AIRWORTHINESS DIRECTIVE

Ref. No. 2019-322-03

Applicability – RRJ-95 aircraft

Pursuant to revealing of the slat section track link crack on RRJ-95 aircraft,

Fig.1

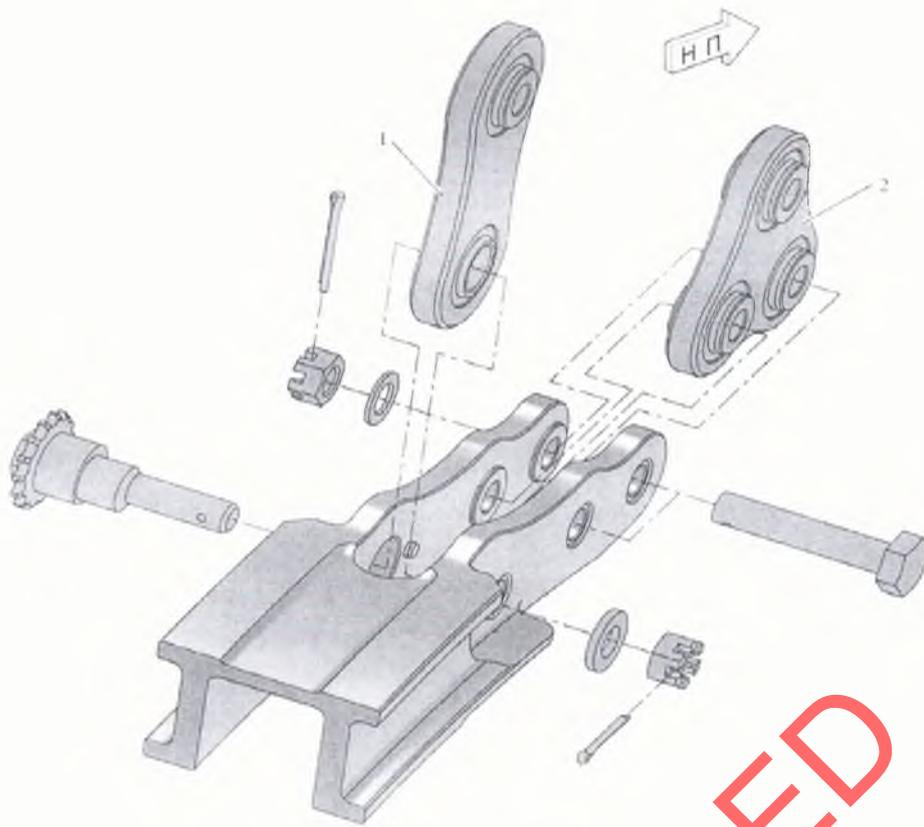
1. Starting from 15.06.2019, during the weekly WY-Check/8 DY on A/C RRJ-95 MSN 95030, 95037 and from 95116 to 95220, to perform the inspections of links of tracks (See. Fig.1 (it. 1, 2) and Fig.2 (it. 3) and bearings of links of track of sections 2, 3 and 4 of slat of LH and RH outer wings in accordance with the provisions of p. 4. Б. (2) and (6) of AMM Tasks No. 57-43-00-220-802, 57-44-00-220-802 and 57-45-00-220-802, until the implementation of SB No. RRJ-57-00451-BD “Wing – Replacement of link of track of slat section” (Planned release date of the SB – 23.05.2019г.)

Once the track link assembly is replaced, continue the inspections of the track links (See Fig.1 (items 1, 2) and Fig.2 (item 3) and the bearings of links of track of sections 2, 3 and 4 of slat of LH and RH outer wings during the weekly WY-Check/8 DY in accordance with the provisions of p.1 hereof and subject to the following conditions:

2. In case of finding a crack of link of track and/or deterioration and press-out of the bearing of link of track of sections 2, 3 and 4 of slat of LH and RH outer wings following the results of implementation of p.1 hereof, it is necessary to replace the damaged track link assembly (track link and bearing), according to the identification information in Table 1 and under the instructions given in AMM Tasks No. 57-43-00-900-804, 57-44-00-900-804 and 57-45-00-900-804
